March 10, 1975

Subject: Dresden Station Environmental
 Technical Specification
 NRC Dkts. 50-237 and 50-249

Subject: Response to NRC Requests (dated Feb. 4, 1975)
re. Dresden Environmental Technical Specifications

DRESDEN STATION THERMAL PLUME
 DATE: 8-10-74 TIME: 1315-1558
 PLUME = 0.29 ACRES

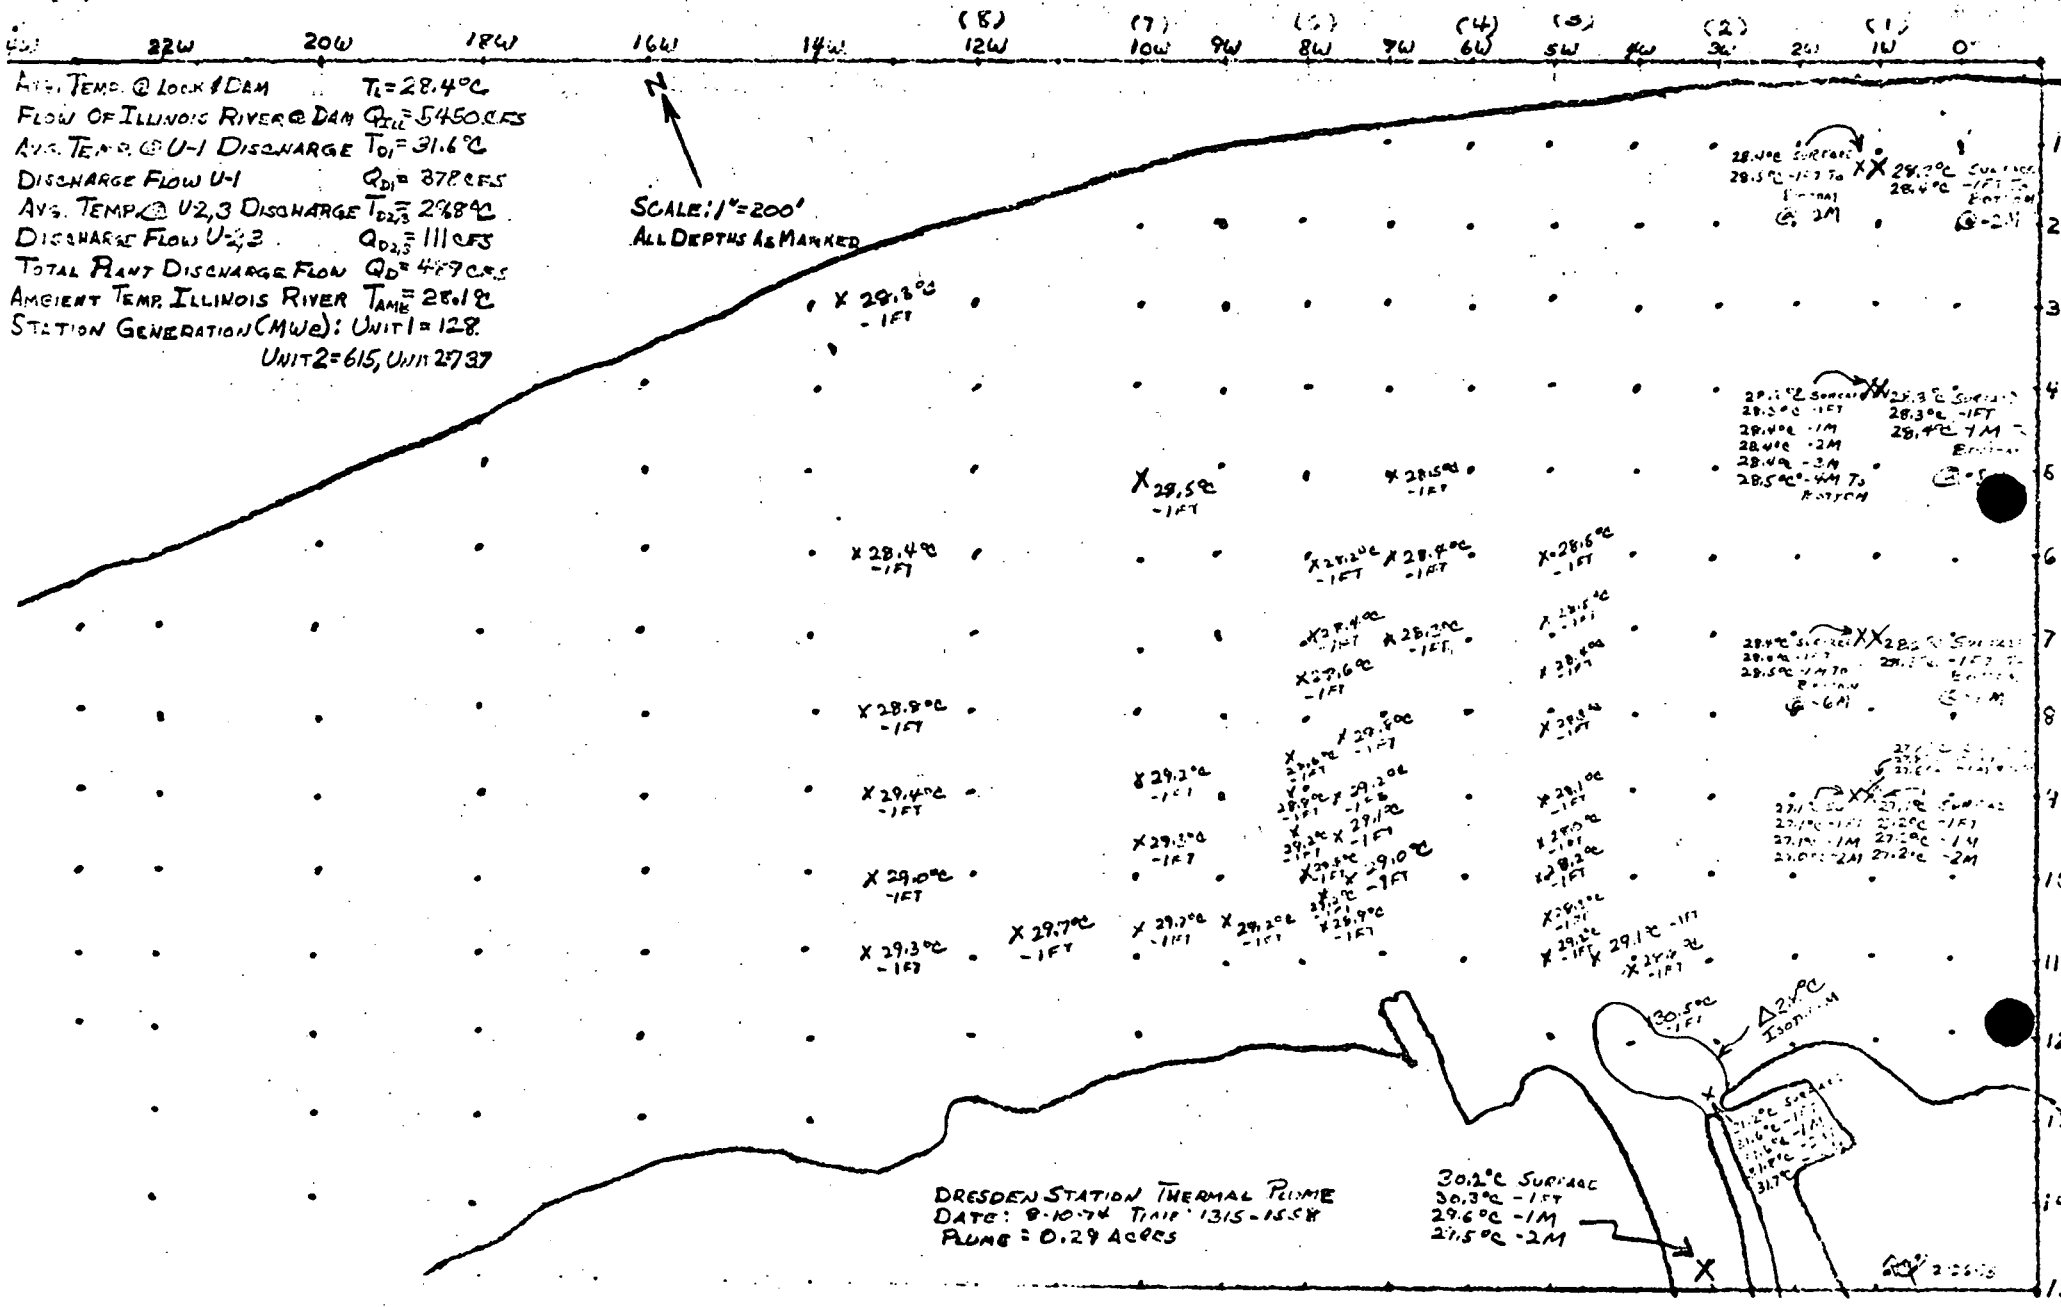
Study of August 10, 1974 (afternoon):

The plant load was 1480 MWe (Unit 1 = 128, Unit 2 = 615, Unit 3 = 737). Flow from the Unit 1 discharge canal was 378 cfs and from the Unit 2, 3 canal was 111 cfs. The river flow was about 5,450 cfs and the ambient water temperature was 28.1°C. The area contained within the excess 2.8°C contour was 0.29 acres.

DRESDEN STATION THERMAL PLUME
 DATE: 10-17-74
 NO OBSERVED Δ 2.8°C PLUME

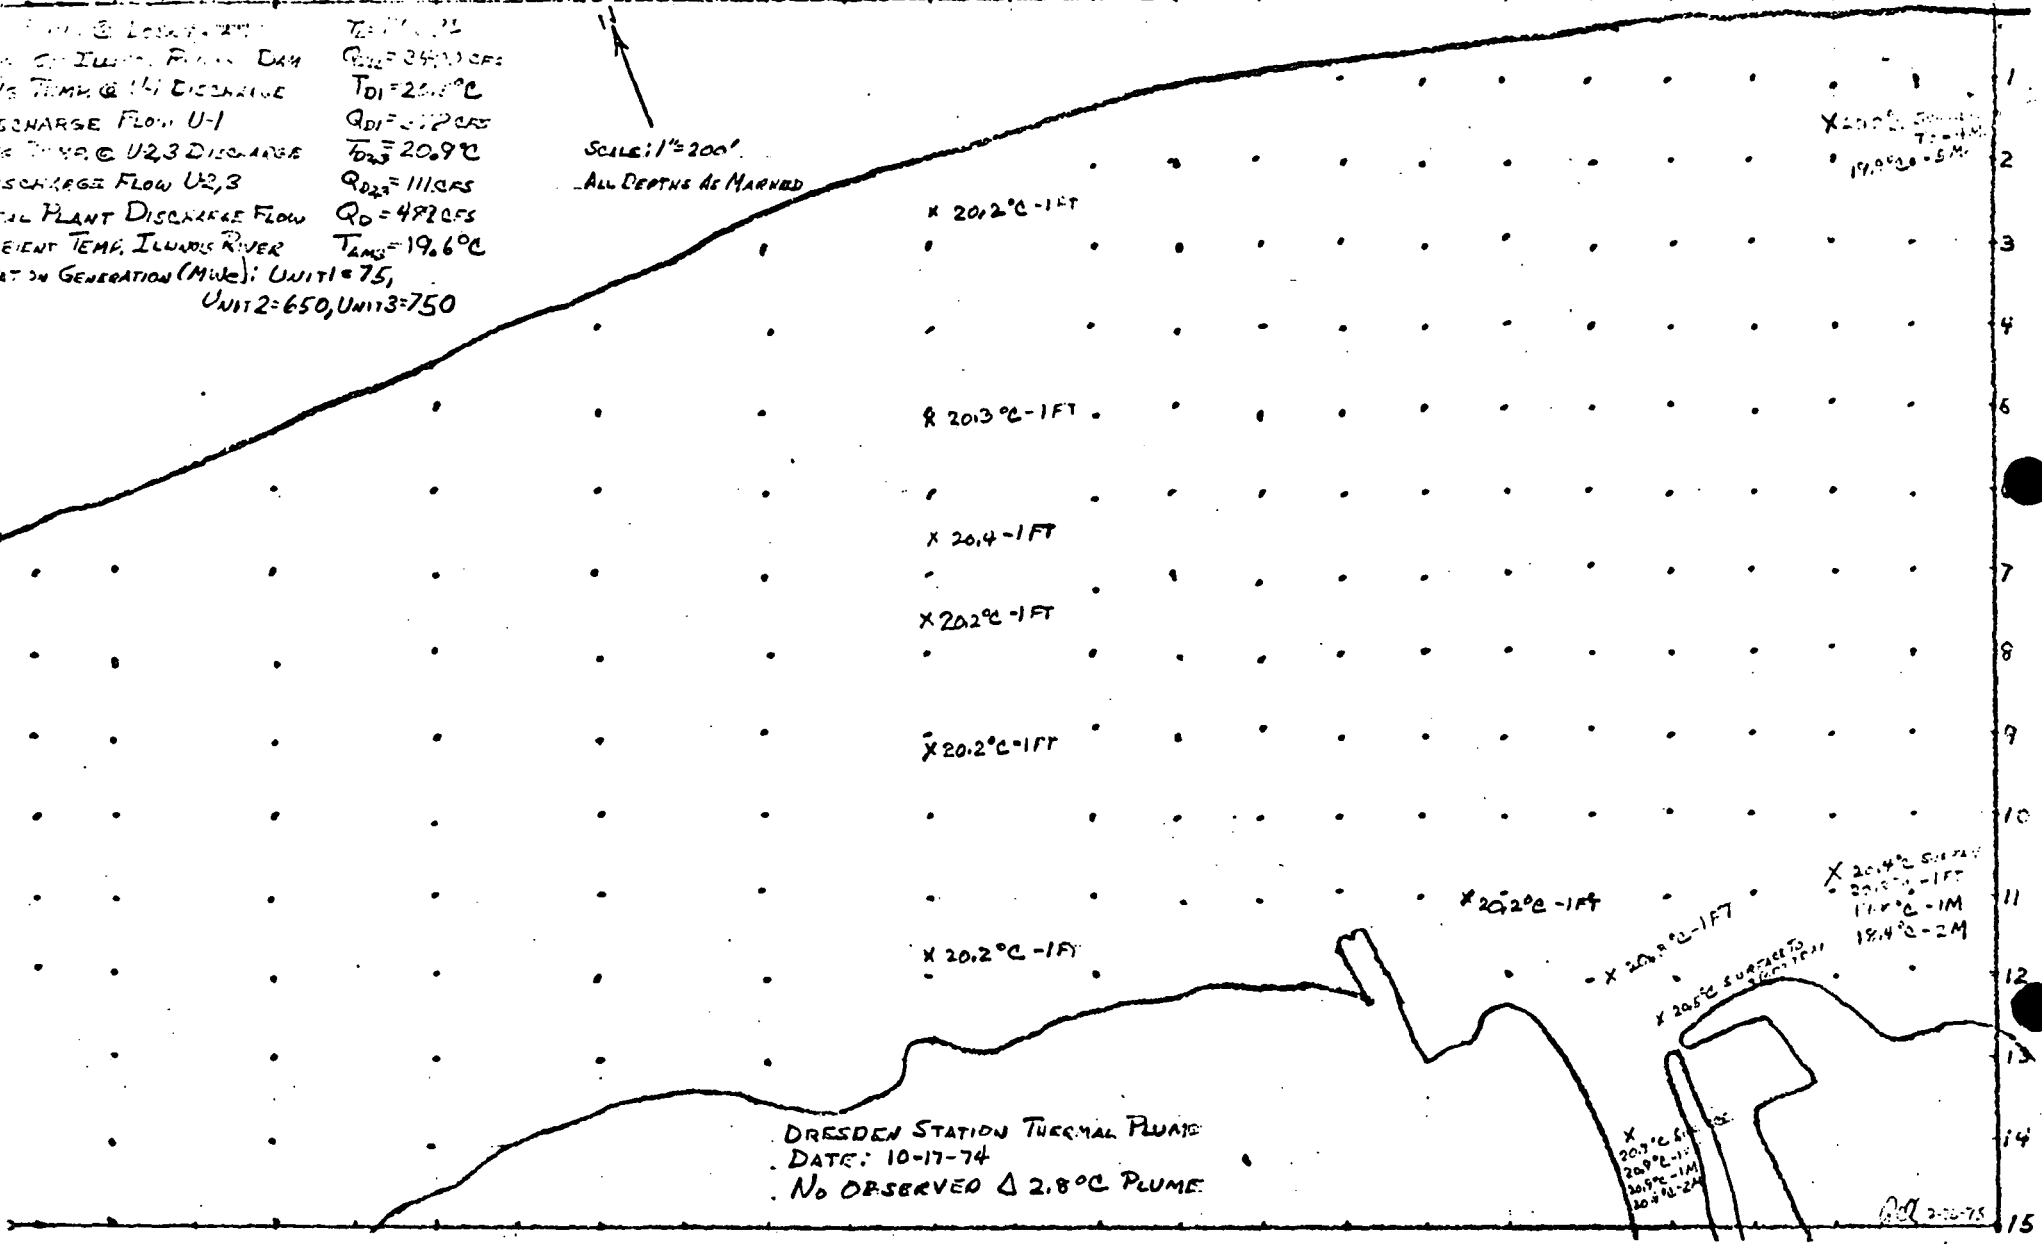
Study of October 17, 1974:

The plant load was 1475 MWe (Unit 1 = 75, Unit 2 = 650, Unit 3 = 750). Flow from the Unit 1 discharge canal was 378 cfs and the ambient water temperature was 19.6°C. There was no

discernable area 2.8°C above ambient.

DRESDEN STATION THERMAL PLUME
 DATE: 10-21-74
 NO OBSERVED Δ2.8°C PLUME

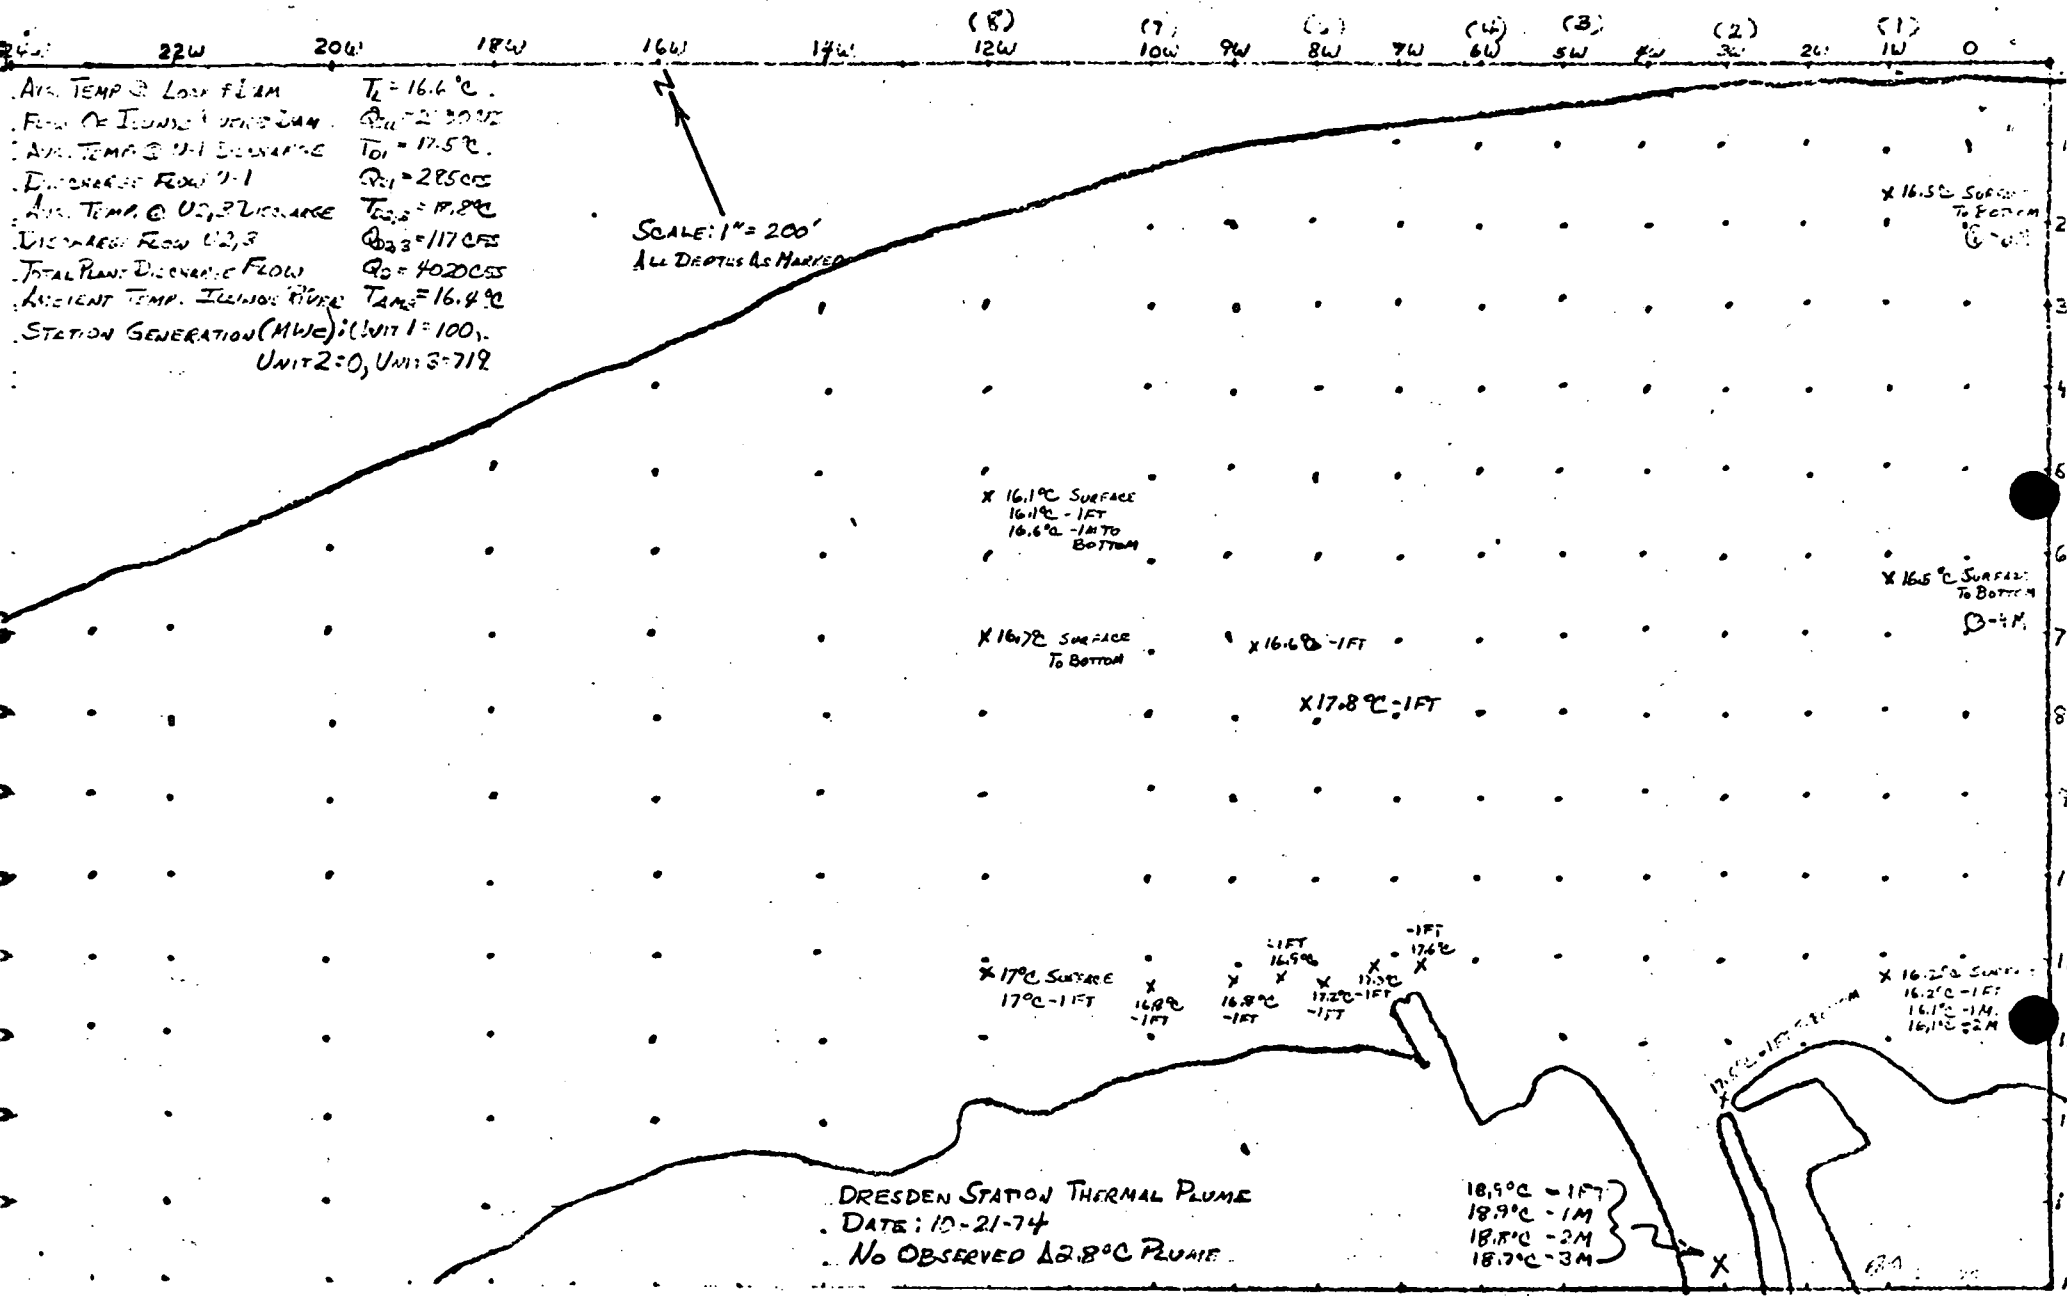
Study of October 21, 1974:

The plant load was 819 MWe (Unit 1=100, Unit 2=0, Unit 3=719). Flow from the Unit 1 discharge was 285 cfs and from the Unit 2,3 discharge was 117 cfs. The river flow was 2800 cfs and the ambient water temperature was 16.4°C. There was no discernable area 2.8°C above ambient.
